SUBJECT: **R.E. Ginna Nuclear Power Plant**
Docket No. 50-244

**Response to Request for Additional Information Re: Fourth Interval
Inservice Inspection Program Relief Requests Nos. ISI-02 and ISI-03**

Response to Request for Additional Information Regarding Relief Request
ISI-02 and ISI-03

System / Weld ID: "B" Steam Generator / NSE-4R

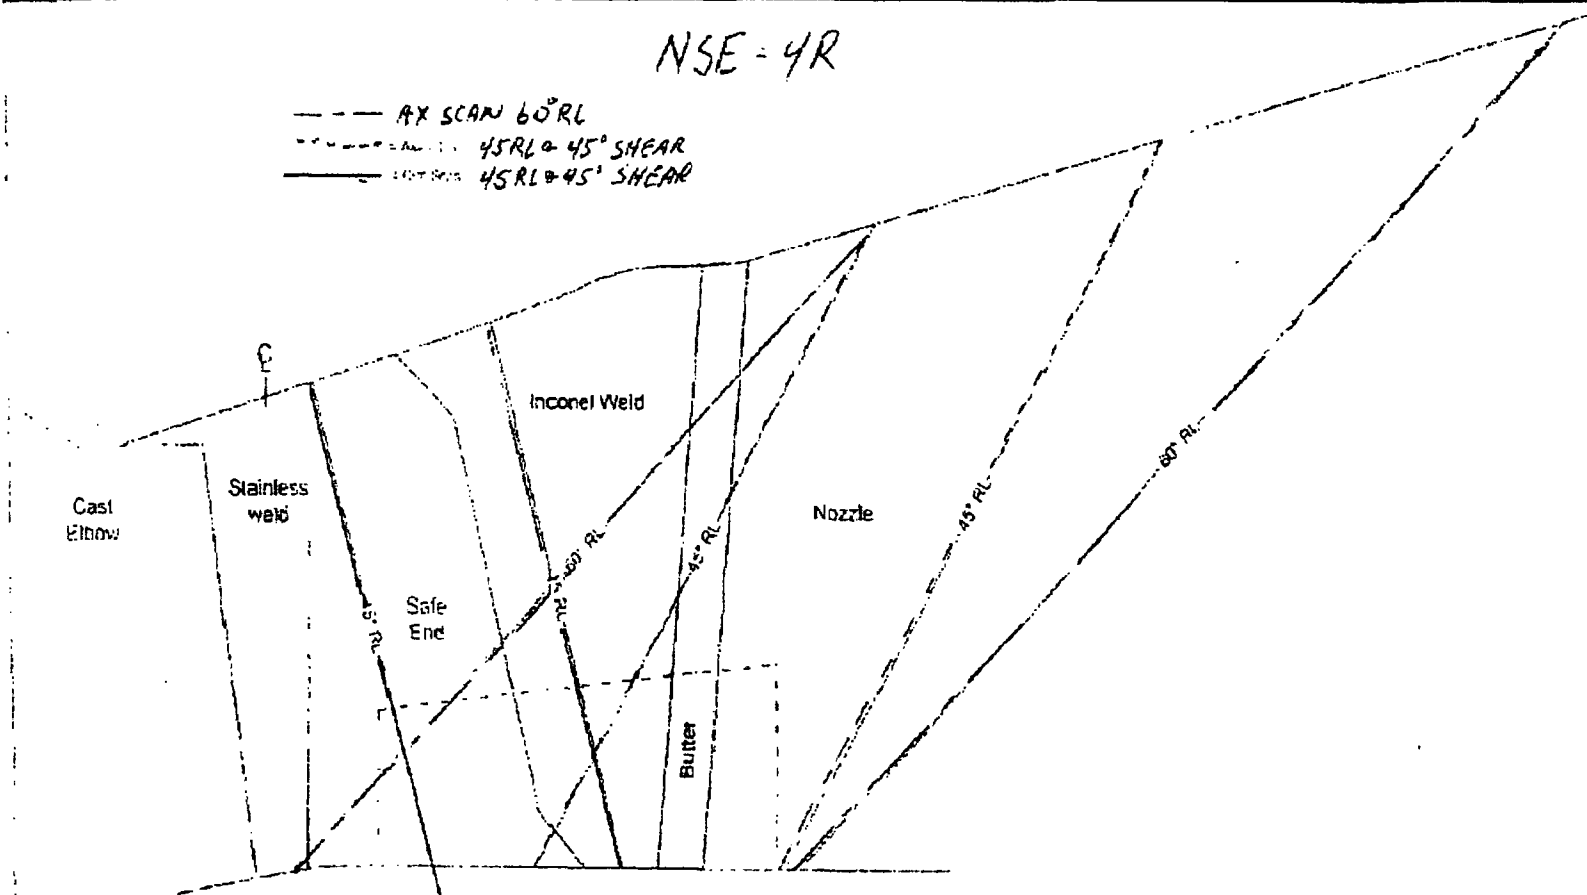
- b. *Please provide a figure and coverage calculations for Component ID NSE-4R (I007190) and coverage calculations for Component ID NSE-3R (I006990). Please ensure that figures provided for both components clearly depict all wave modalities and insonification angles used (please note that the figure and caption should match) and examination limitations encountered. Please keep in mind that the figures are transmitted as black and white, so that different styles of lines should be used to distinguish between axial and circ scans or, if necessary, provide a figure for each of the scan directions.*

- c. *It is the NRC staff's understanding that the Performance Demonstration Initiative (PDI) program requires two angles in order to claim ASME Code coverage for a Supplement 10, single side exam. Please clarify whether your Code coverage calculations were made using two angles. Did a single angle provide greater coverage? If so, how much?*

- b. The Ginna ISI Vendor provided additional coverage calculations to support the examination record coverage final figures as provided. See Attachment # 1.

- c. Yes, the site examination record indicates a combined Code coverage % using multiple scan angles by the ISI Vendor coverage calculations. See Attachment # 1.

The percentage calculation for NSE 4R would be 52% for the 45 RL, 52% for the 60-RL, 32% for the circumferential clockwise examination, and 32% for the circumferential counter clockwise examination. This results in a coverage of 42%

For NSE 4R, the 60 RL coverage was 96%, the 45 RL circumferential clockwise examination was 32%, and the circumferential 45 RL counter clockwise examination was 32%. This results in a coverage of 53.3%

Achieved coverage of the circumferential examinations, as illustrated, was reduced by 45% due to loss of contact and restricted ability to perform skewed scans, as required by Technical Justification IR-2(109-381), as a result of surface condition.

Attachment 2a
Examination Coverage for RC-PL-FW-XV

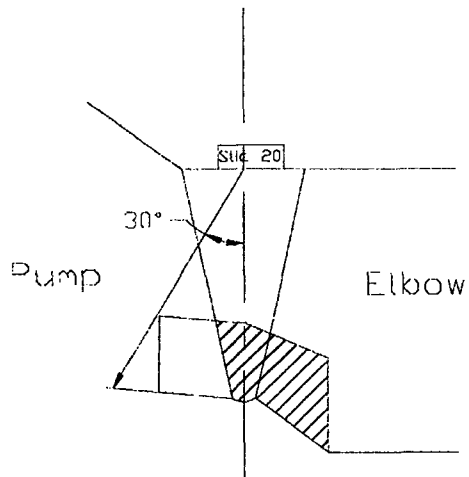
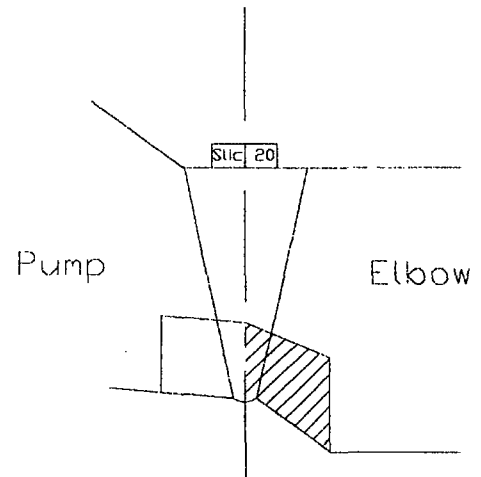
- b. *For Component ID PL-FW-XV (I013500), the use of insonification angles of 20°L/30°L is atypical. Was the procedure qualified to the PDI? Were these angles used for both the axial and circumferential scans? Why weren't any shear wave exams performed? Lastly, the sketch of this component for the axial exams indicates that there was coverage on the pump side, even though the pump is cast. Please provide clarification.*

- b. This ISI weld (PL-FW-XV) configuration is a Cast Stainless Steel elbow to Cast Stainless Steel pump casing, therefore the procedure used was not qualified to PDI. The procedure used manual ultrasonic with best available technology, where grain structure contributes to considerable sound attenuation and diffusion. The ISI vendor provided a search unit (SLIC20) to the site that produced a better signal to noise response than the 45° shear wave used previously (1995). The ISI vendor demonstrated on the site's CSS calibration block that the 20°L/30°L search unit could see the ID notch at the component thickness (2.4") as compared to the shear wave. Based on these facts, the weld was examined with these transducer angles. Coverage plot and transducer focus plot information are provided in Attachment 2a and 2b.

Examination Coverage:	
Axial Coverage Down	= 62%
Axial Coverage Up	= 0%
Parallel Coverage CW	= 50%
Parallel Coverage CCW	= 50%
Average	= 40.5%
